Historical Architectural Review Board

COA Preliminary Review Sheet

HDC-2025-00028

Address: 1548 Chew Street

Existing Front Elevation (Google Maps, April 2024)

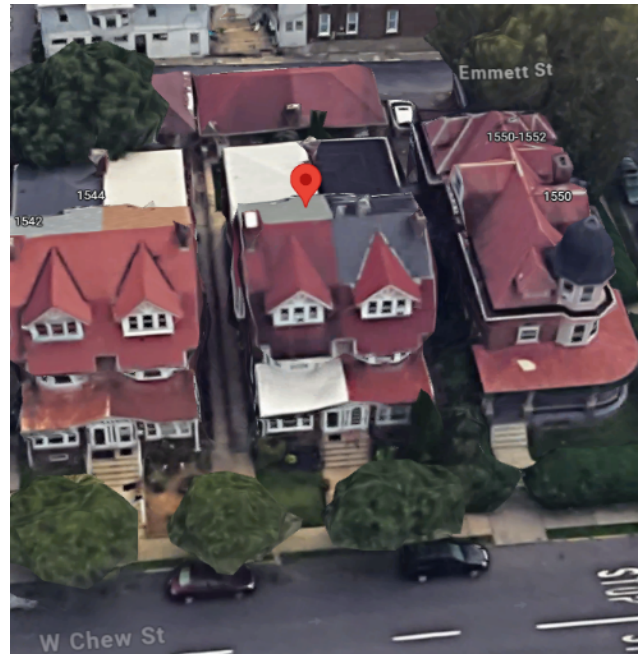
Observations & Comments: From previous City surveys, it appears that this property has had red asphalt shingles since the early 2000s. The proposed GAF Slateline product more closely resembles the original clay tile roof that would have been on the house (as seen in adjacent buildings). It does not appear that GAF Slateline has a red product to more closely match the color of clay tile.

From this application and some recent similar applications, it appears that a readily-available substitute product for red clay tile is difficult to source. The Guidelines note that terra cotta tile roofs are a character-defining feature of the West Park Historic District. Considerations for this application include the various qualities of roofing material; if matching color, pattern, and profile are not all available in the current market, is there a priority aspect? Staff observe that GAF Slateline provides a similar profile and pattern as the original clay tile but does not offer a red option. A replacement red asphalt shingle would be an in-kind replacement to the current roof and be consistent in color, but would not provide the profile and pattern as the GAF product.

Mr. Hart discussed the two approaches to material selection; profile, shape, and durability versus color, given the challenges to material availability. Mr. Jordan noted that in most cases, color is least important, but there is a contextual aspect to this application in that several adjacent buildings are red roofed. The HARB discussed the context of red roofs vs a red roof of a different material. The applicant suggested that other designer shingles may have more options.

Staff Recommendation: Staff recommend approval of an in-kind replacement roof (red, 3-tab asphalt shingles), or an approved alternate material as discussed by the HARB.

Mr. Hart moved to approve the application presented on May 5, 2025, for the replacement of roofing at 1548 Chew Street with the following conditions agreed to by the applicant, following section of the Guidelines for Historic Districts: Chapter 3, Section 3.1-Roofs and found circumstances unique to the property in that the roof was previously replaced and that roof color is contextually important to this block.:

- The color be preserved.
- The roofing material and shape would match original if possible, based on the guidelines.
- Present product to staff for approval; color and stylistically appropriate
